DRAINAGE BASIN MAP

project title: OAKLAND AVENUE ALBUQUERQUE, NM

sheet title: DRAINAGE PLAN

DEVELOPED

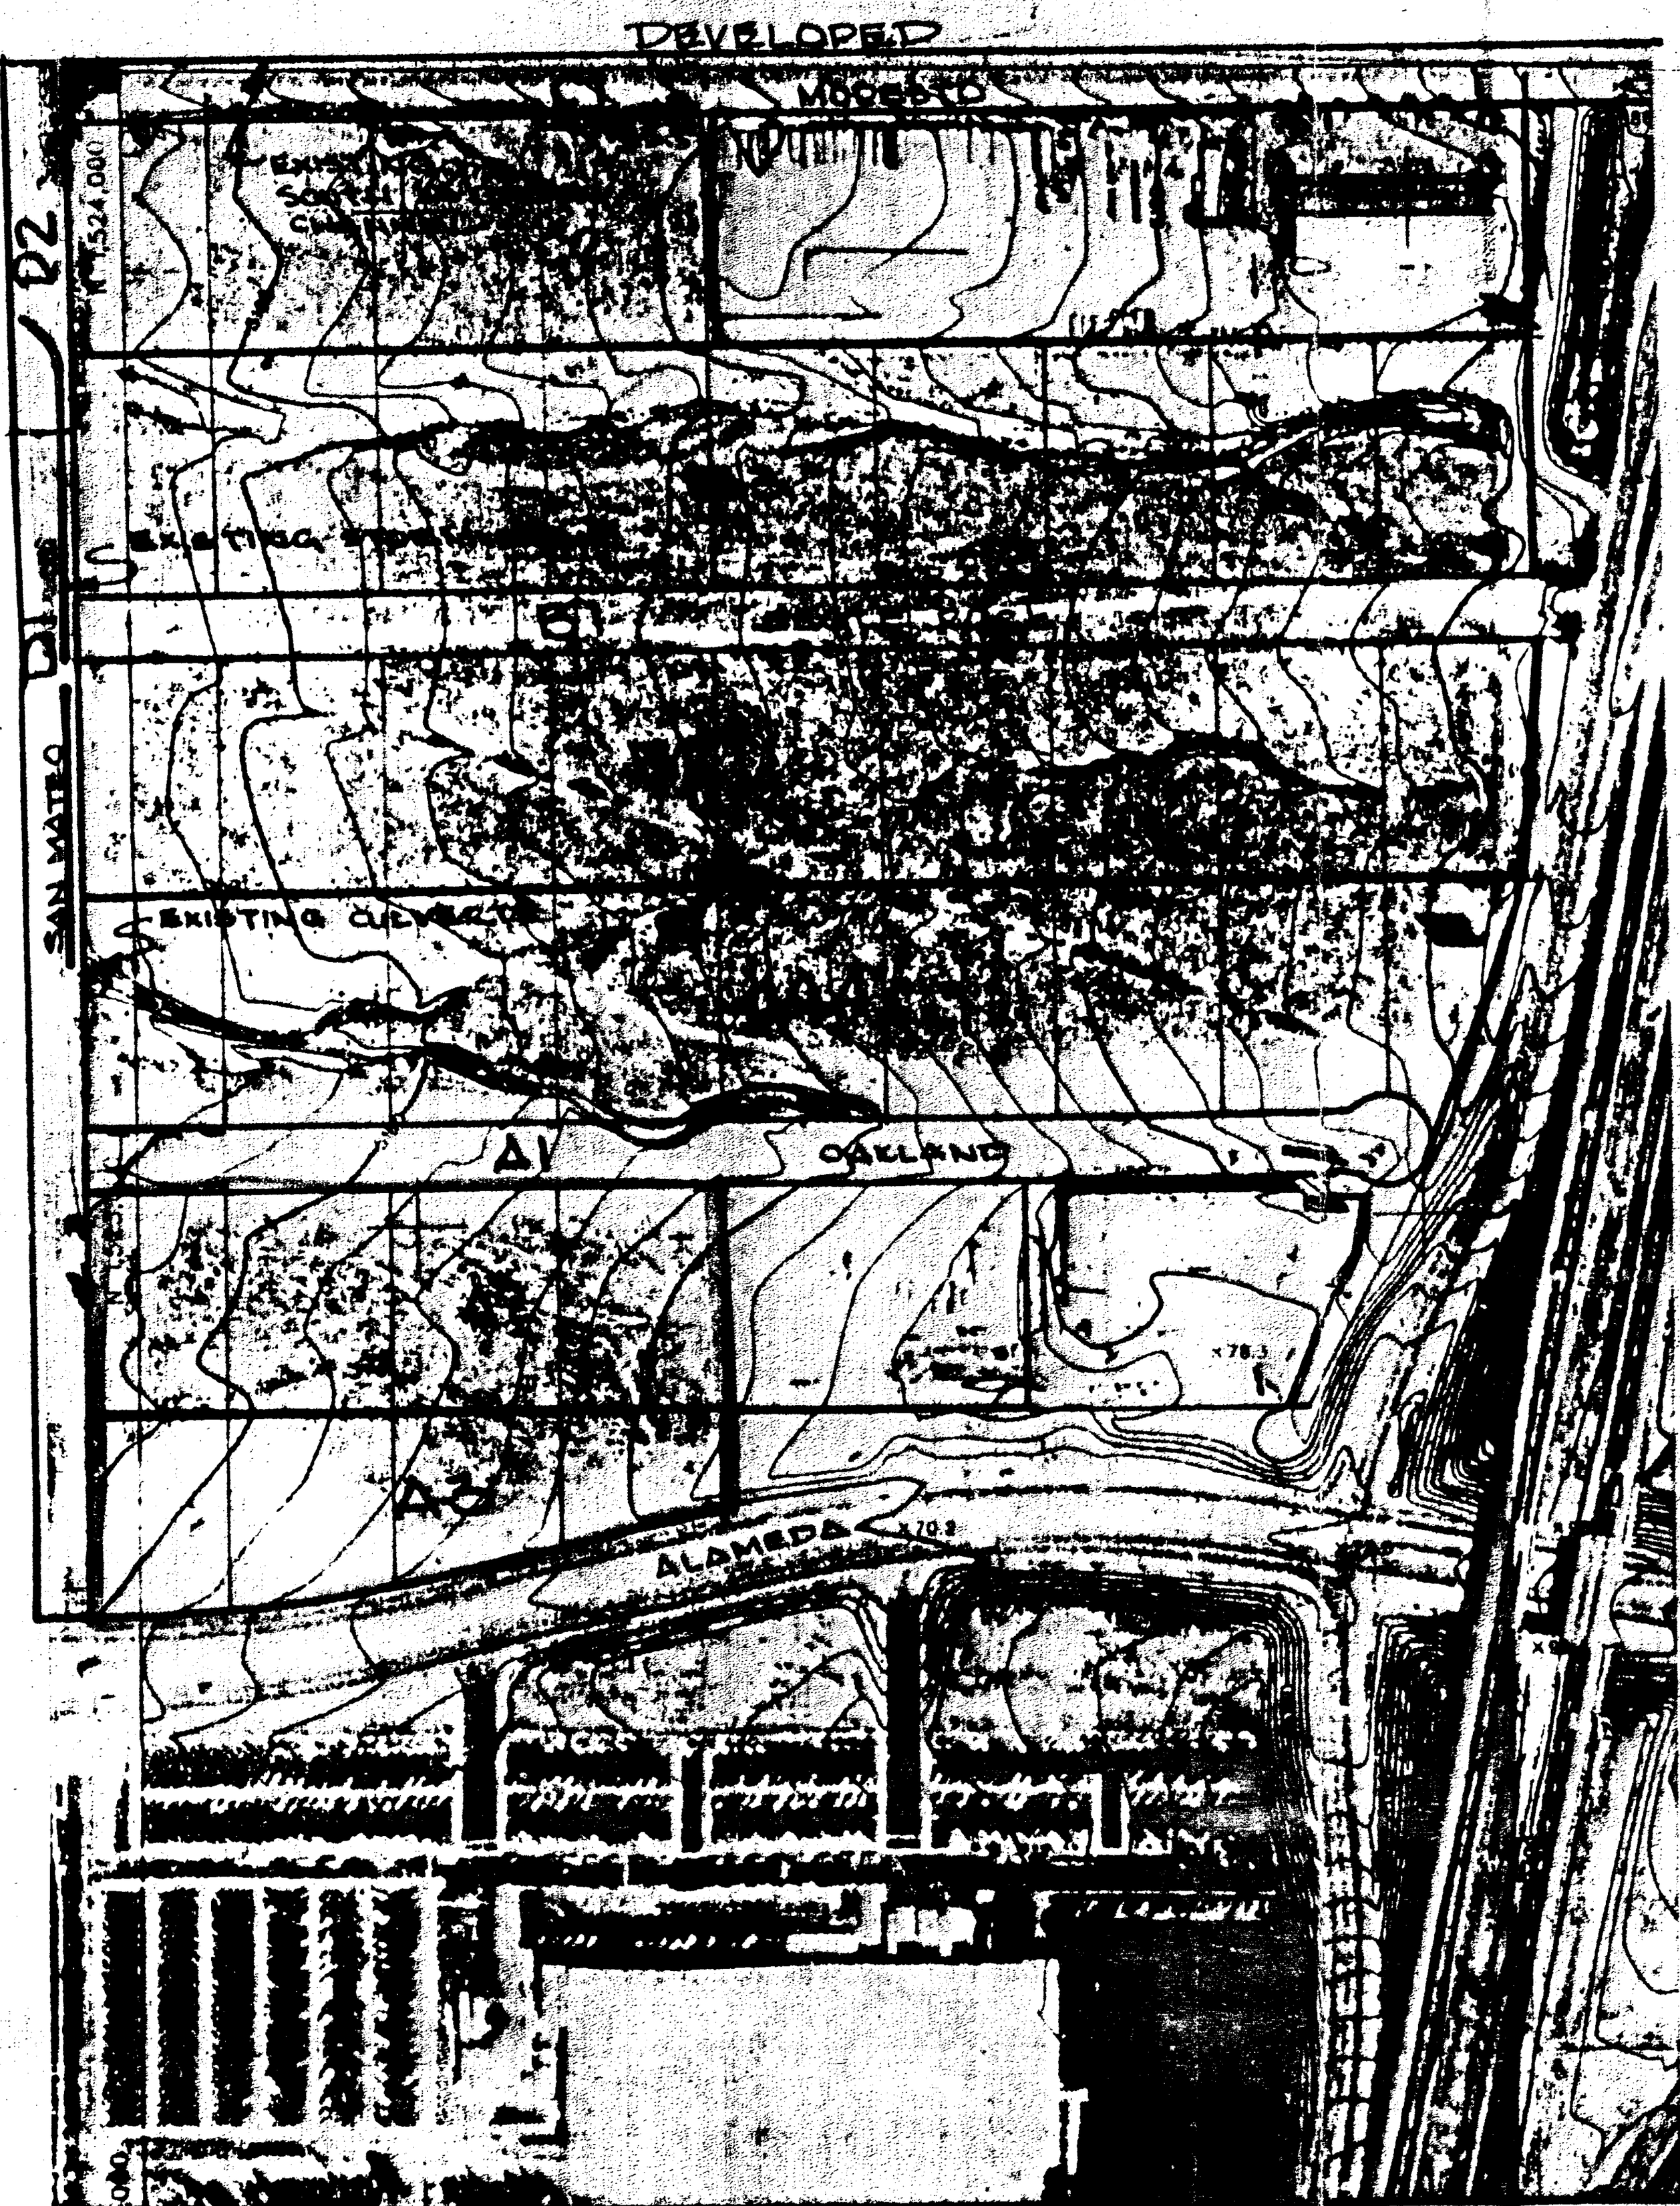
Basin A3 (developed) won't ever get to Oakland

looks overcapacity
